## **Meadowbrook Park**

**PUD Development Plan, Preliminary Plan, Pre-Development Site Grading &  
Wet Utilities**

### **Letter of Intent**

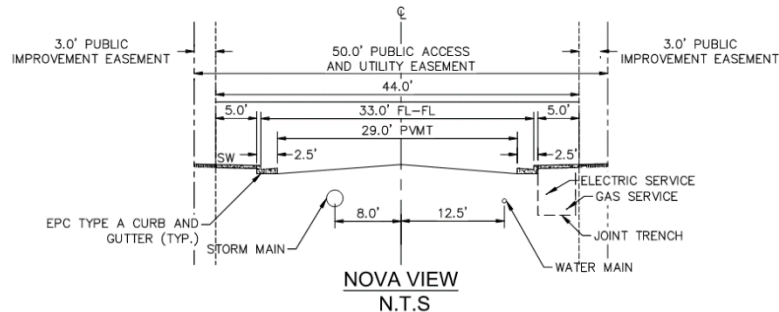
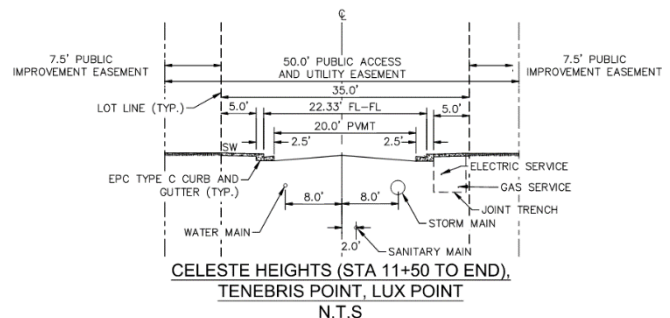
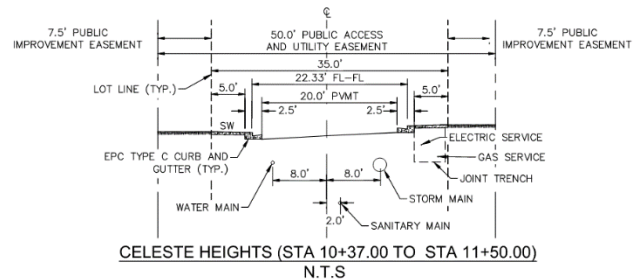
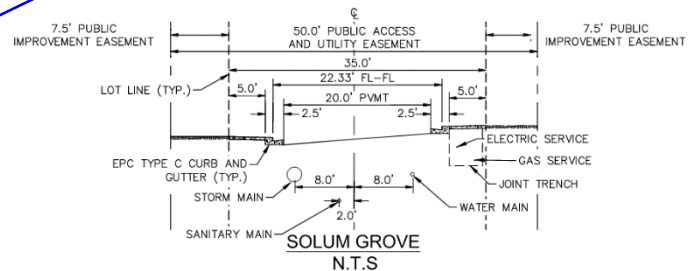
Review 1 comment: Deviations from the County standards such as the pavement width proposed will require that deviation request forms be submitted.

Justification must be identified in the Letter of Intent as an attachment which addresses criteria in the deviation request form. Please refer to the ECM Section 5.8. For an example of how this has been done by other consultants please refer to the letter of intent (page 12) of PCD file No. PUDSP204

**Review 2:** Unresolved. Please also submit the deviation request form addressing the review 1 comments.

The modified cross sections shown do not match the urban local low volume cross section. The urban local low volume has a pavement width of 24' with (2) 12' travel lanes. Please revise the statement.
